Pentium[®] II Xeon[™] Processor Specification Update

Release Date: October 1999

Order Number: 243776-016

The Pentium[®] II Xeon[™] processor may contain design defects or errors known as errata which may cause the product to deviate from published specifications. Current characterized errata are documented in this Specification Update.

Figure 1. An Example of Microcontroller Driven Thermal Management

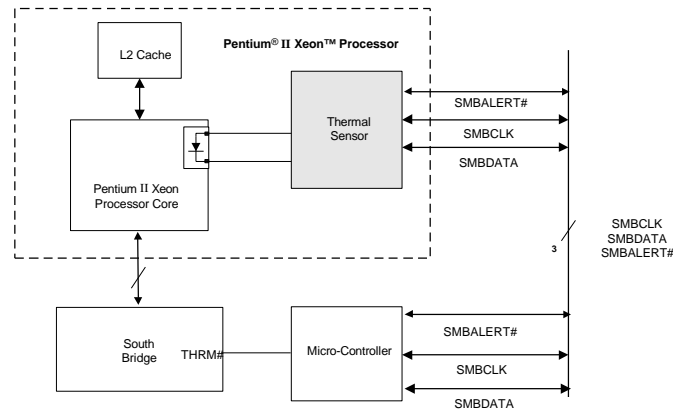
D30. Thermal Sensor May Assert SMBALERT# Incorrectly

Problem: The Pentium II Xeon processor has a thermal sensor that monitors the processor core's temperature. The thermal sensor asserts SMBALERT# if the processor temperature exceeds the temperature limits set in the Alarm Threshold Registers (T_{HIGH} , T_{LOW}). It also sets the corresponding Status Register bits to identify the cause of the interrupt. Figure 1 gives one example of the how the SMBALERT# signal could be used in a system.

Under the conditions described below, the thermal sensor incorrectly generates the SMBALERT# interrupt. All of the following conditions must be met to trigger a false interrupt:

Workaround: Three different (mutually exclusive) workarounds are possible:

1. Before servicing an interrupt from the thermal sensor, read and compare the processor thermal reading with the threshold limits (T_{HIGH} or T_{LOW}). Figures 2 and 3 provide basic flowcharts for the implementation of this workaround in an interrupt driven system.
2. If the firmware implemented polls the Status Register only, then before taking any action, re-read the temperature register and do a comparison with the alarm threshold limits (T_{HIGH} or T_{LOW}) to determine if the value is actually still within the temperature window.
3. Use a temperature polling scheme to monitor the processor temperature.
